ARGEST FIRE
SURVEY REPORT
FIRE SPRINKLER SYSTEM

8 BURNHAM STREET
PETONE,
WELLINGTON
19 NOVEMBER 2024
FSC ID 2360

AMENDED 29 NOVEMBER 2024
VERSION 2

Water Storage Tanks Findings

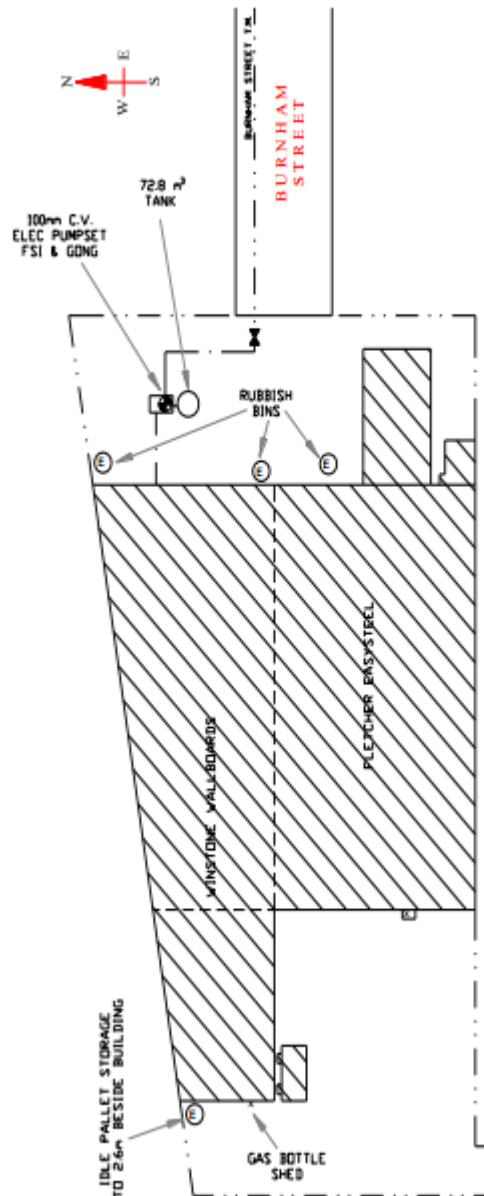
12. There is no evidence the tank has been cleaned in the last 12 years.
